Supplementary Information

Owner: Sheridan Retail Inc.

2225 Erin Mills Parkway

Concept Plan - Zone A

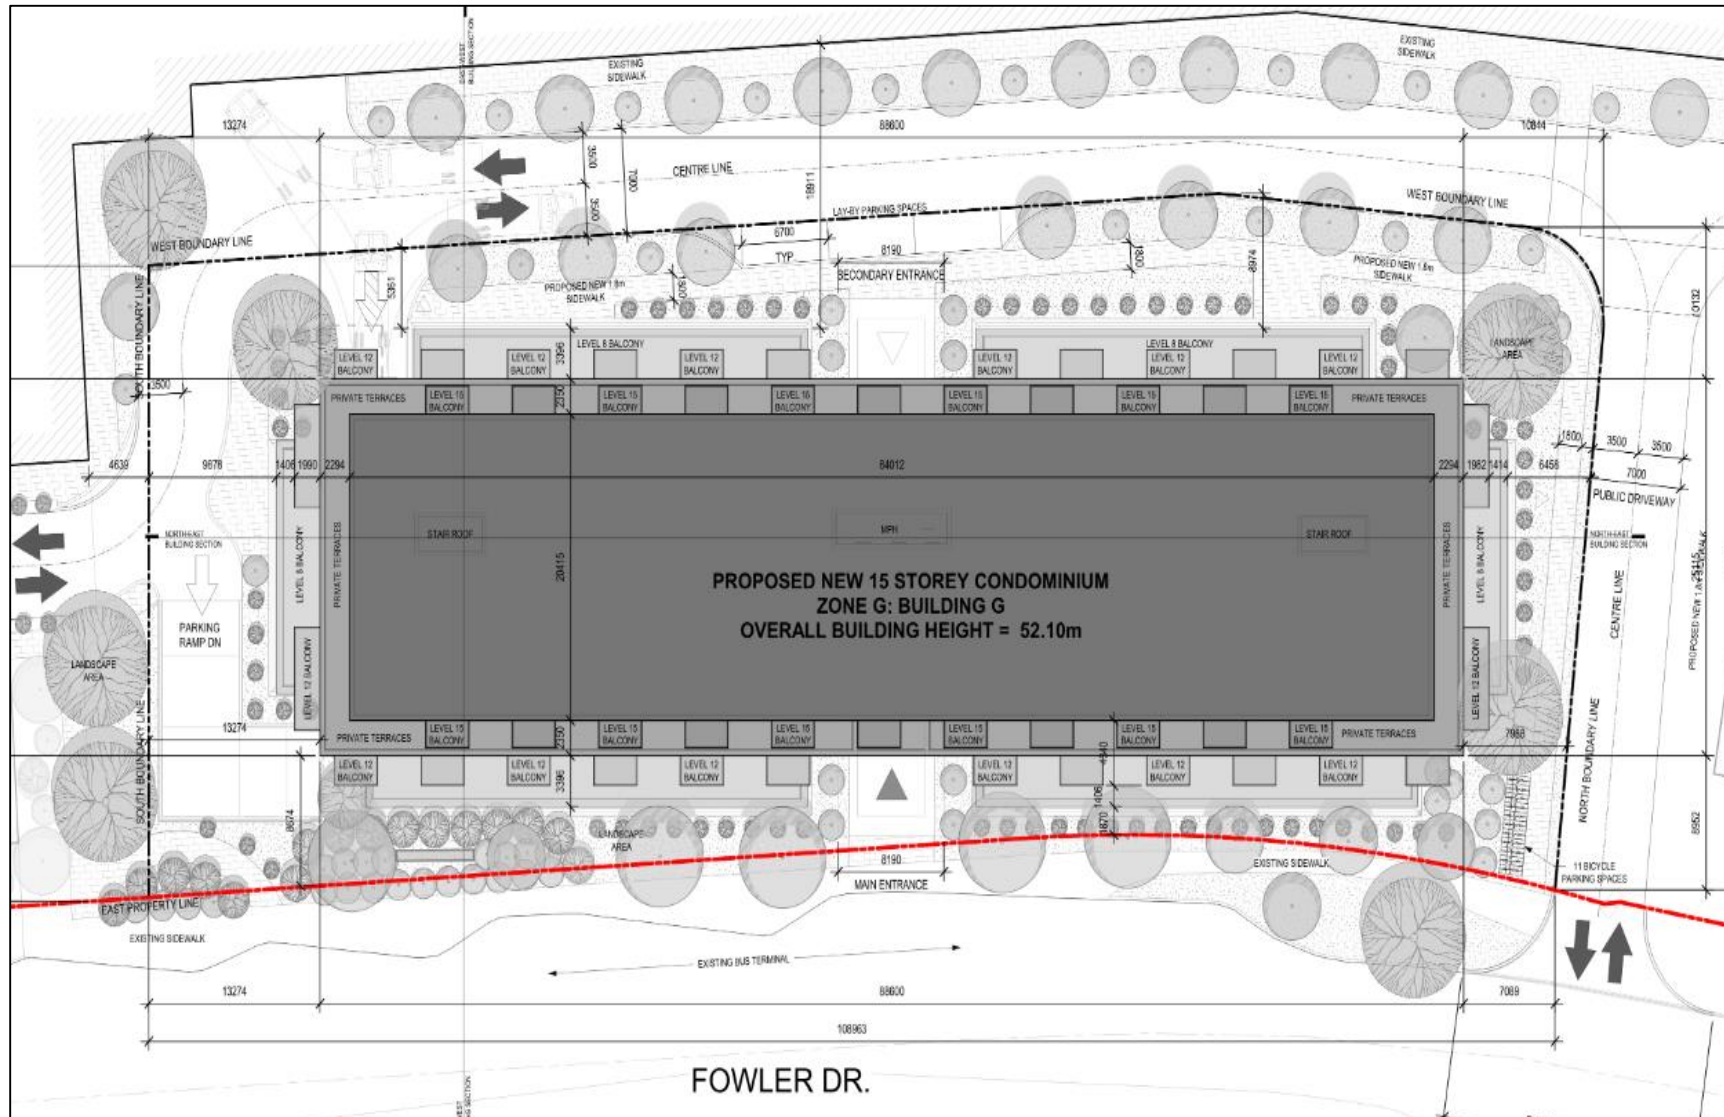
<p>Fire Prevention Plan Examination (September 2023)</p>	<p>The proposed building in Zone A exceeds the maximum 15 m (49.2 ft.) limit from the proposed fire route under the Ontario Building Code.</p> <p>Additional information is required regarding the distance of the proposed building in Zone G from the drive lane of Fowler Drive to confirm compliance with the Ontario Building Code. Buses parked in the adjacent bus terminal spaces cannot obstruct the maximum 15 m (49.2 ft.) limit from a fire truck. If the proposed north entrance for the building is required for fire access, the proposed private road will need to be shown as a fire access route. Confirmation is required through a formal resubmission.</p>
<p>City Planning Strategies – Housing (September 2023)</p>	<p>The applicant is encouraged to consider revising the proposed development to provide additional three bedroom family-sized units. The submitted Housing Report does not address ROP policies with respect to new housing unit targets and the provision of affordable housing or purpose-built rental housing.</p>
